Access Compliance Report

Public Rights-of-Way

Intersection ID: 16126	Main Street: E_W_T_HARRIS_BV	Cross Street: IDLEWILD_RD	Location: SW
ADA ID: 9456A3DF30F2	Ramp Type: PerpDiag	Initial Pass/Fail: Fail	Overall Compliance: No
Severity Score: 12.5			
Codes/Mitigation Info/Possible Solution		Field Measurements/Component Compliance

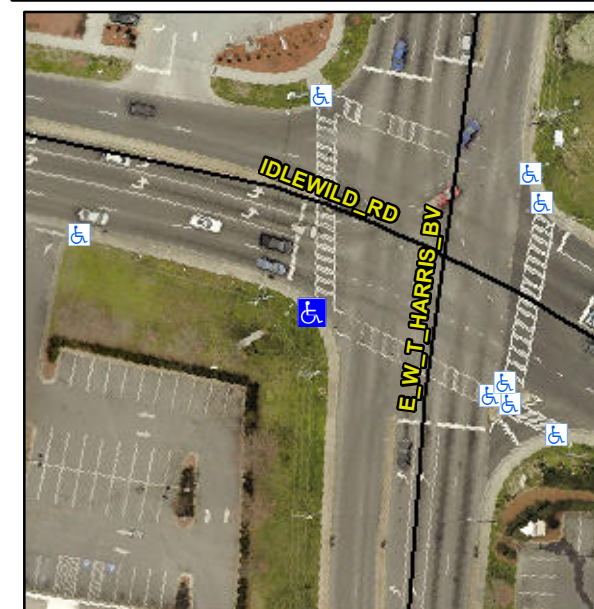
Compliance	Description	Data	Compliance	Description	Data
N/A	Ramp Length (in)	60.0	No	Ramp Slope (%)	9.7
Yes	Ramp Width (in)	48.0	Yes	Ramp XSlope (%)	0.2
N/A	Flare Type LT	N/A	N/A	Flare Type RT	N/A
N/A	Flare Slope LT (%)	N/A	N/A	Flare Slope RT (%)	N/A
N/A	Flare Traversable LT?	N/A	N/A	Flare Traversable RT?	N/A
N/A	Landing Length (in)	N/A	N/A	DWS Provided?	N/A
N/A	Landing Width (in)	N/A	N/A	DWS Contrast?	N/A
N/A	Landing Slope (%)	N/A	N/A	DWS Length (in)	N/A
N/A	Landing X Slope (%)	N/A	N/A	DWS Full Width?	N/A
N/A	Landing Curb? (Y/N)	N/A	N/A	DWS Offset (in)	N/A
N/A	Shared Landing?	N/A			
N/A	Gutter Ponding?	N/A	N/A	Gutter Slope (%)	N/A
N/A	Gutter Lip Ht (in)	1.0	N/A	Gutter X Slope (%)	N/A
N/A	Painted X Walk1?	Yes	N/A	Painted X Walk2?	Yes
	X Walk 1 Direction	To SE		X Walk 2 Direction	To NE
N/A	X Walk 1 Width (in)	121.0	N/A	X Walk 2 Width (in)	107.0
	X Walk 1 Slope (%)	2.8		X Walk 2 Slope (%)	4.5
	X Walk 1 X Slope (%)	5.5		X Walk 2 X Slope (%)	4.5

N/A	Ramp inside XWalk1?	Yes	N/A	Ramp inside XWalk2?	No
	Road Slope (%)	0.1	N/A	Clear Space?	N/A
	Road X Slope (%)	6.9	N/A	Clear Space to XWalk (in)	N/A
N/A	Any Obstructions?	N/A	N/A	Storm Grate/Utility Hazard?	N/A
	Obstruction Type			Storm Grate/Utility Type	
		N/A			N/A
		Yes		Surface Condition? (G/P)	Good

Remove & Replace Curb Ramp With Two New Directional Ramps or Equivalent. Restripe Crosswalk.
